**TISDALE SUBDIVISION OF THE FISHER TRACT,  
SQUARE 25, RESUBDIVISION OF LOTS 12 & 13**

APPLICATION NUMBER 11 DATE November 5, 2009

REQUEST Subdivision

# DETAIL SITE PLAN

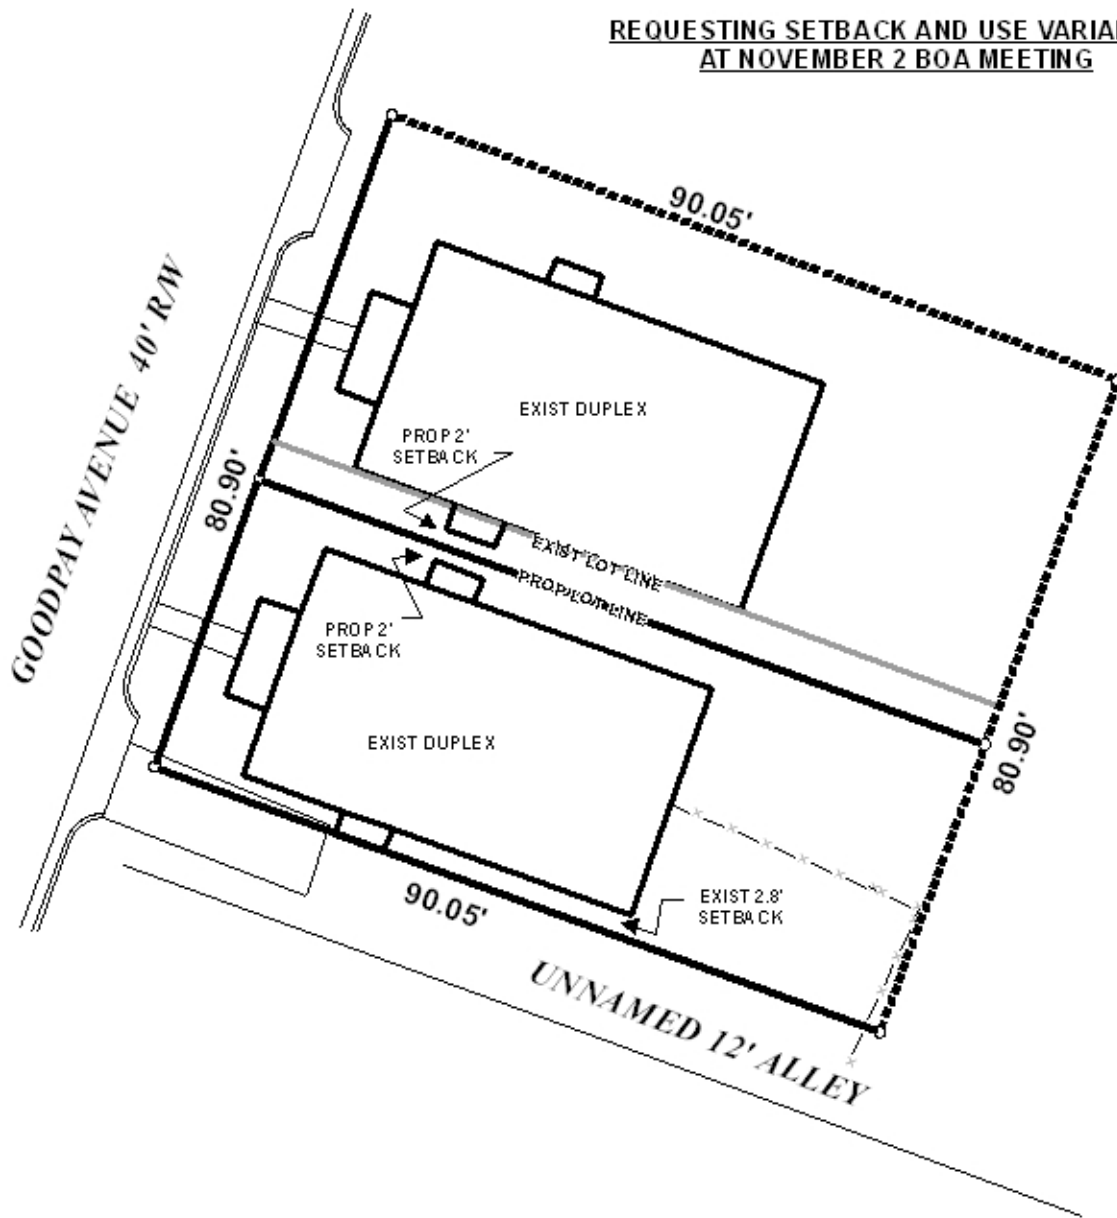
The purpose of this application is to resubdivide two existing lots of record into two lots of record via an adjustment of the common property line between the two. There is currently an encroachment of a covered porch on existing Lot 13 onto existing Lot 14, and the relocated property line between the two is proposed to split the difference between the two structures.

The proposed subdivision has frontage on Good Pay Street with a non-compliant 40' right-of-way. Ordinarily, dedication to provide 25' from the centerline would be required; however, to require such would place the new right-of-way line slightly within the existing front porch on proposed Lot 2 and along the front of the front porch on proposed Lot 1. Therefore, dedication should be waived in this instance. The plat should be revised to indicate a 30' minimum building setback line along Good Pay Street as measured from the current right-of-way line. As a means of access management, a note should be required on the final plat stating that each lot is limited to one curb cut to Good Pay Street, with the size, location, and design to be approved by Traffic Engineering and conform to AASHTO standards. An unnamed, unopened public alley with a non-compliant 12' right-of-way width is adjacent to the South side of proposed Lot 1. Normally, an alley requires a 20' right-of-way. However, to require dedication to provide 10' from the centerline would place the new right-of-way line within the existing dwelling on proposed Lot 1; therefore, dedication along the alley should also be waived in this instance. A note should be required on the final plat stating that Lot 1 is denied direct access to the alley until such time it is developed to a 20' right-of-way.

- 1) illustration of a 30' minimum building setback line as measured for the existing right-of-way line along Good Pay Street;
- 2) placement of a note on the final plat stating that each lot is limited to one curb cut to Good Pay Street, with the size, location, and design to be approved by Traffic Engineering and conform to AASHTO standards;

- 3) placement of a note on the final plat stating that Lot 1 is denied direct access to the alley until such time that it is developed to a 20' right-of-way;

- 4) labeling of each lot with its size in square feet, or the provision of a table on the plat furnishing the same information;
- 5) approval of the proposed 2' Side Yard Setback Variance for each lot by the Board of Zoning Adjustment;
